Impact of a Draft URCP on BCs & OTs following MSC 96

The Shipbuilders' Association of Japan

Urgent Rule Change Proposal(URCP)

Safety factor in usual ships

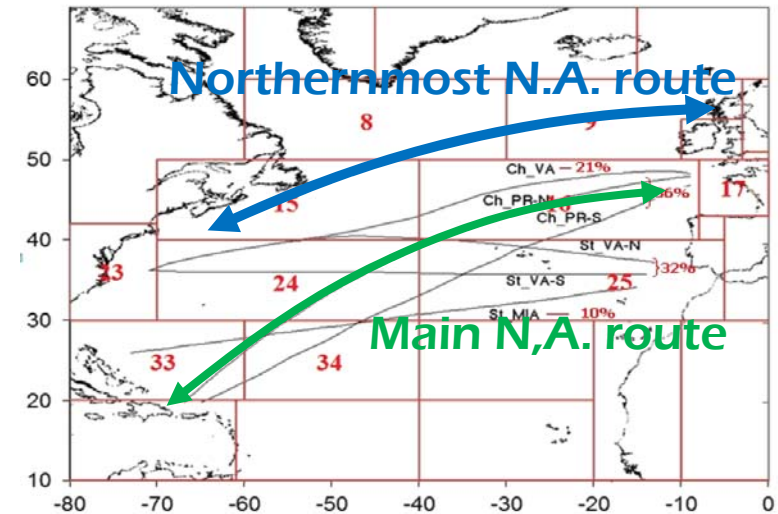
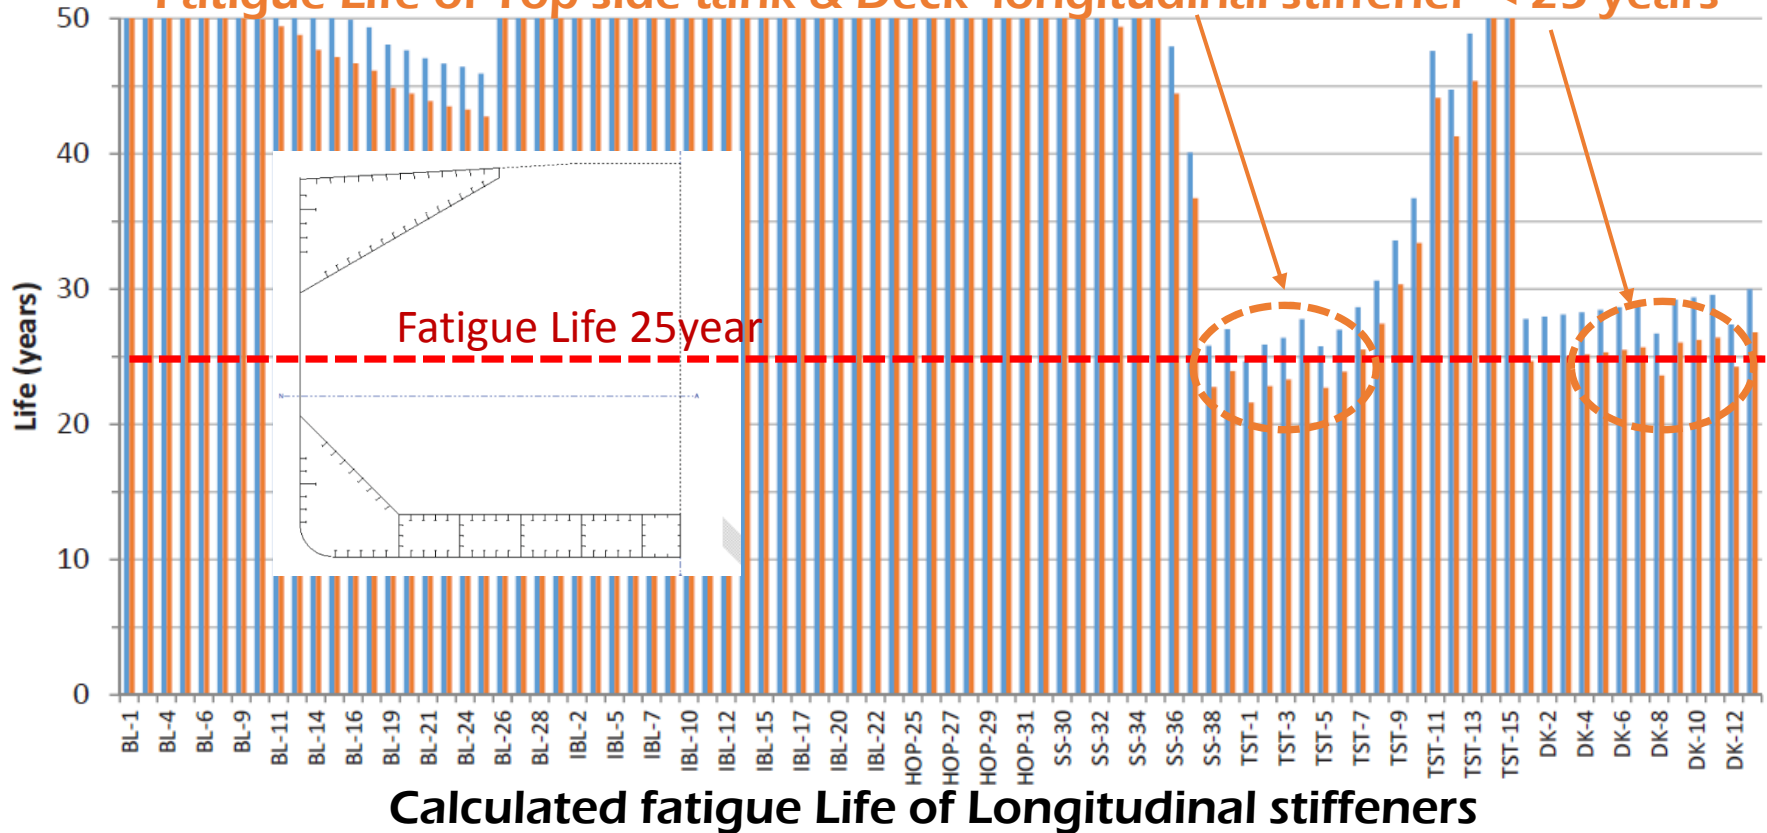
Wave load ($Q = 10^{-2}$) on Northernmost N. A. route (CSR for BC & OT)
= 1.12 x Wave Load on Main N.A. route

Safety factor in fatigue life :
Around 1.4 (=1.12³)

Safety factor in fatigue life :
Around 2.8 (=2.0 x (A))

**Present CSR for BC & OT provide usual ships
with sufficient safety level .**

Impact analysis (IACS TB of Draft URCP:NC04)

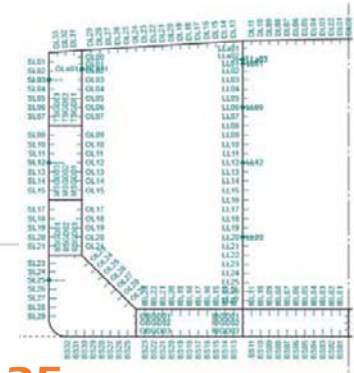
Cape size BC : BC3/Loaded Hold/Fwd Connection

Fatigue Life of Top side tank & Deck longitudinal stiffener < 25 years

Large impact on deck longitudinal stiffeners

Impact analysis (IACS TB of Draft URCP:NC04)

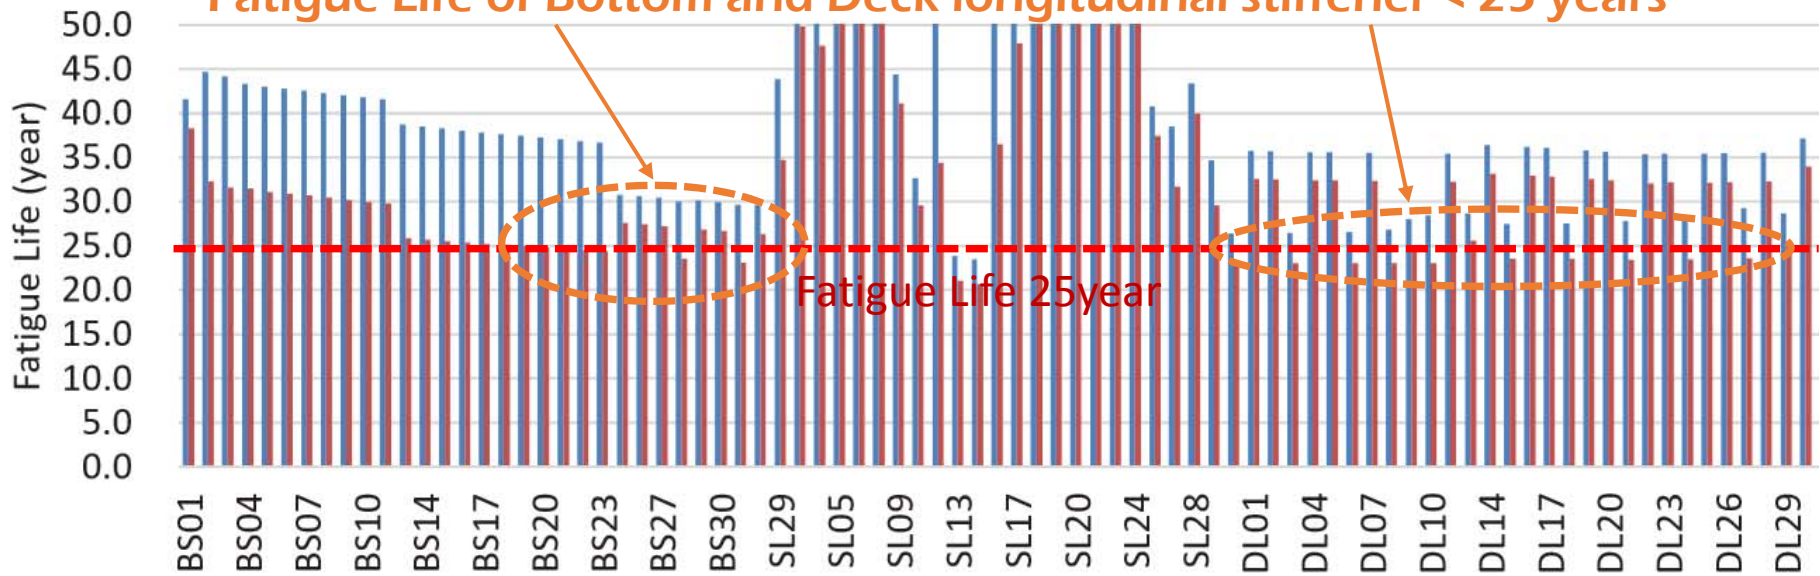
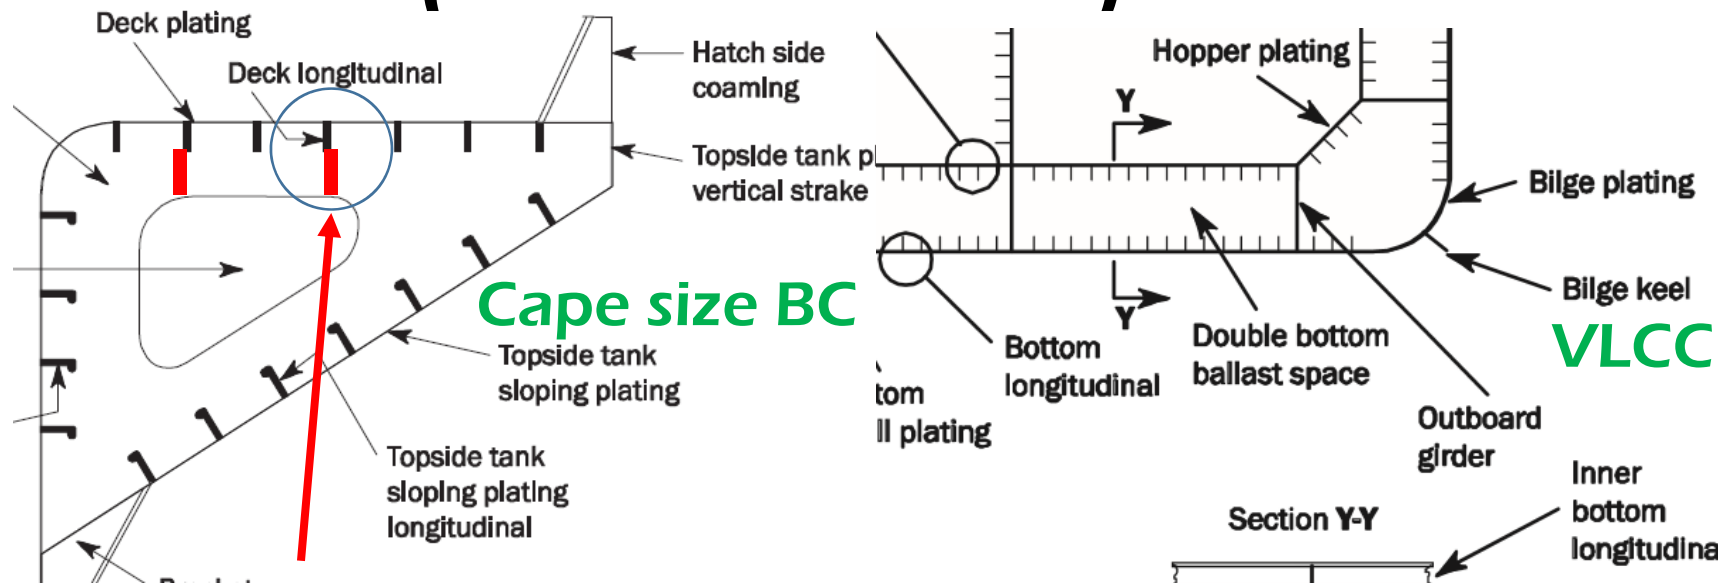
VLCC: Oil tanker OT2

Fatigue Life of Bottom and Deck longitudinal stiffener < 25 years

Calculated fatigue Life of Longitudinal stiffeners

Large impact on bottom longitudinal stiffeners

Impact study (Draft URCP:NC04)

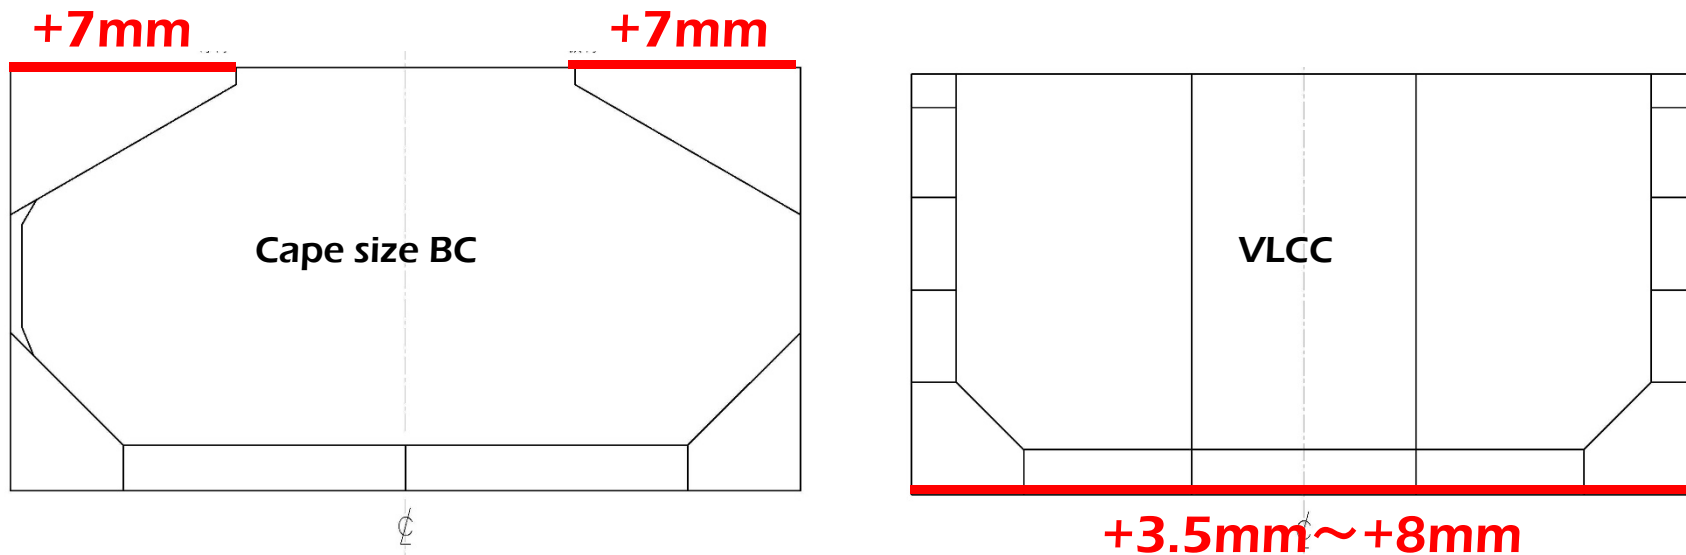
- ◆ Increased hull girder section moduli at deck and/or bottom of large BCs and OTs

abt. +7mm for deck plates of Cape size BC
abt. +3.5~8mm for BTM plates of VLCC

Impact study (Draft URCP:NC04)

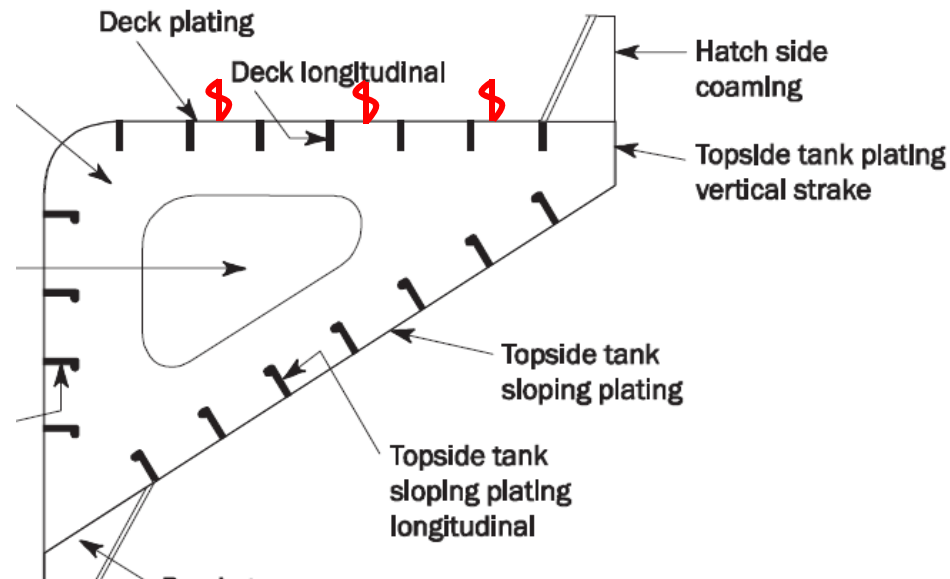
Deck plate thickness of Cape size BC : max 49mm

Challenges and difficulties of One-side Submerged Arc Welding
